DEVELOPMENT REVIEW BOARD REPORT

CASE NUMBER/
PROJECT NAME **McDowell Village Senior Housing
98-DR-2003#2**

REQUEST Revisit the location of the trash enclosure for the McDowell Village Senior Apartments.

SITE PLAN
 SCALE: 1" = 40'-0"

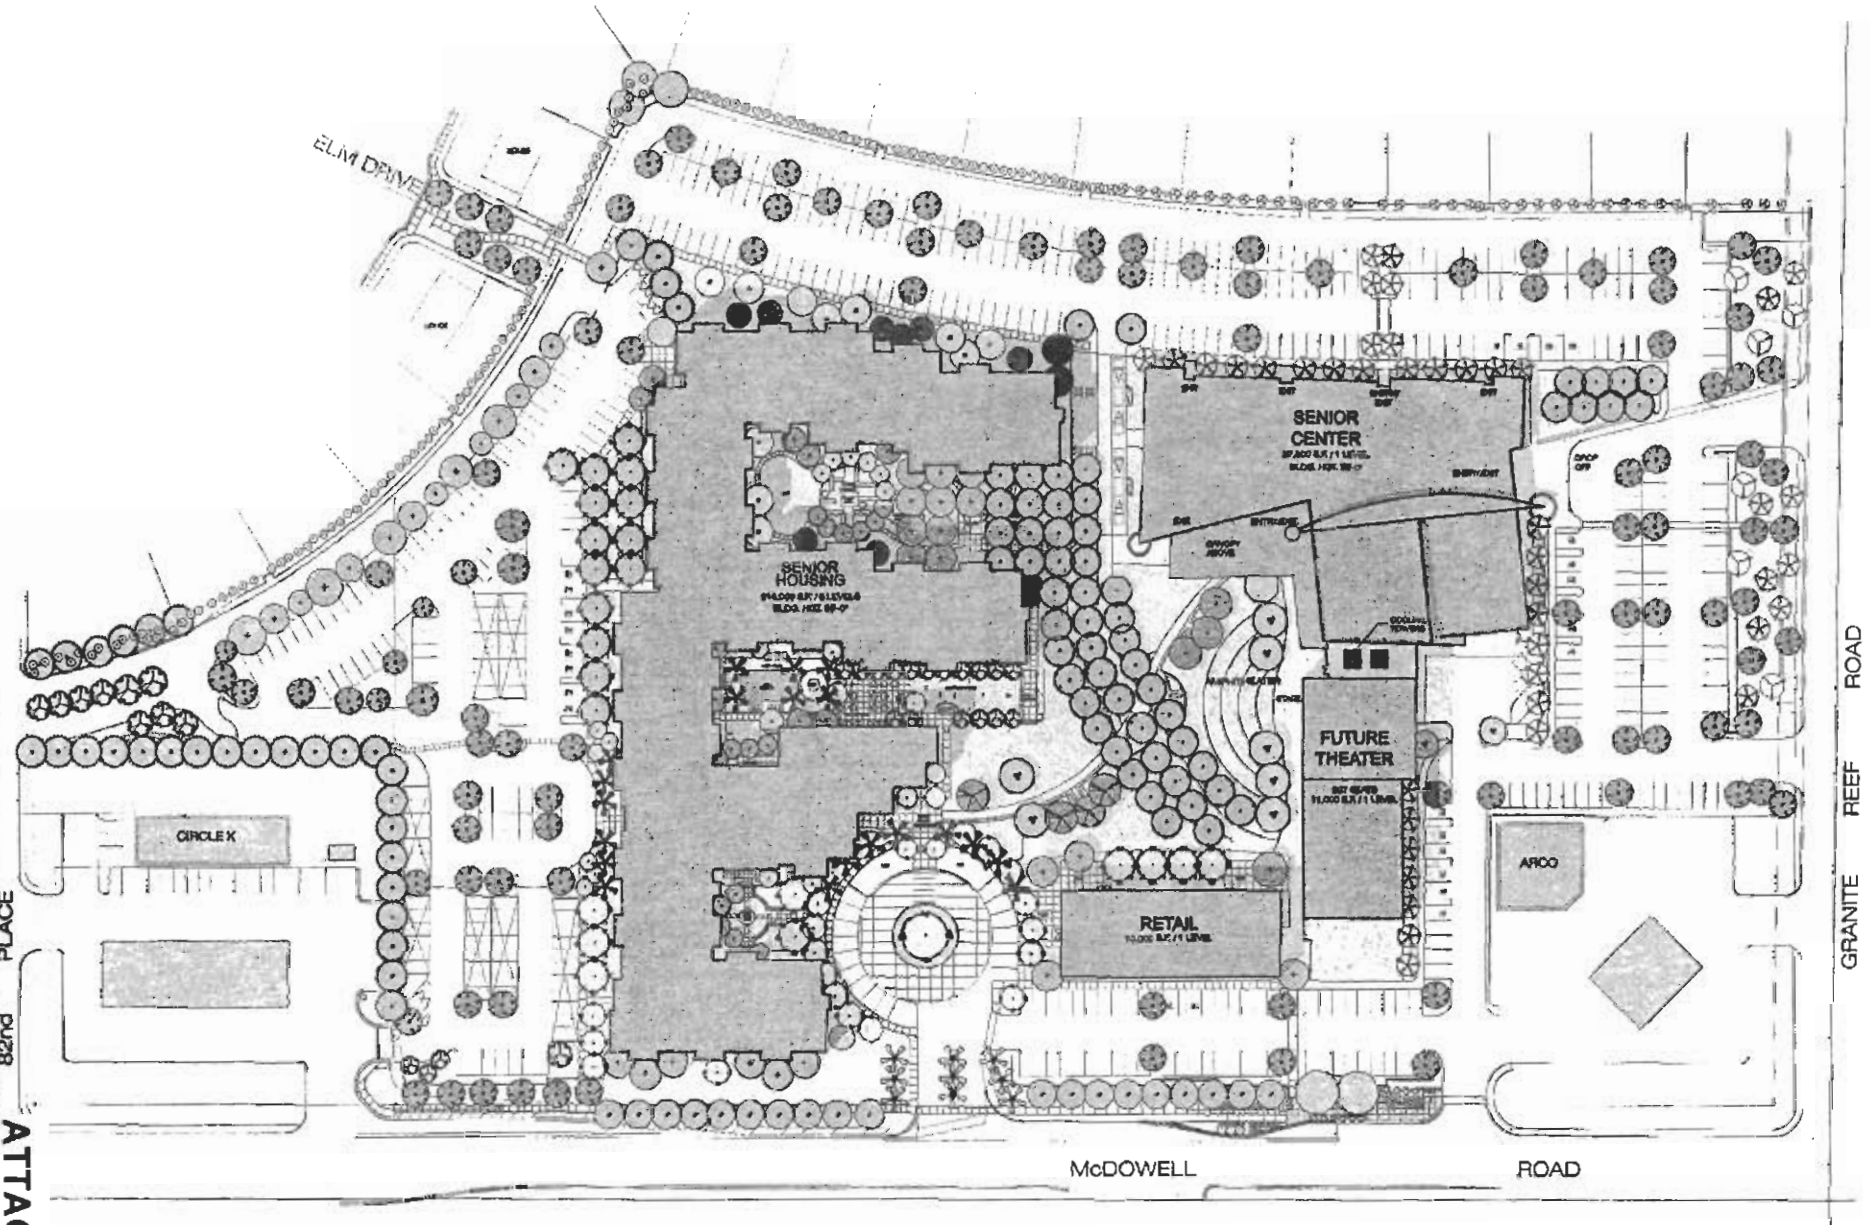
33. The refuse enclosure identified on the referenced applicable documents in the southeast corner of the property must be orientated at 30-degree angle to the centerline of the drive.

34. The refuse enclosures identified on the referenced applicable documents in the northeast corner of the site must be reorientated to facilitate container pickup

35. Enclosures must:
 - a. Provide adequate truck turning/backing movements for a design vehicle of turning radius R (minimum) = 45 feet vehicle length of L = 40 feet.

- b. Be positioned to facilitate collection without "backtracking."
 - c. Be easily accessible by a simple route.
 - d. Not require backing more than 35 feet.

- e. Not be located on dead-end parking aisles.
 - f. Enclosures serviced on one side of a drive must be positioned at a 30-degree angle to the centerline of the drive.
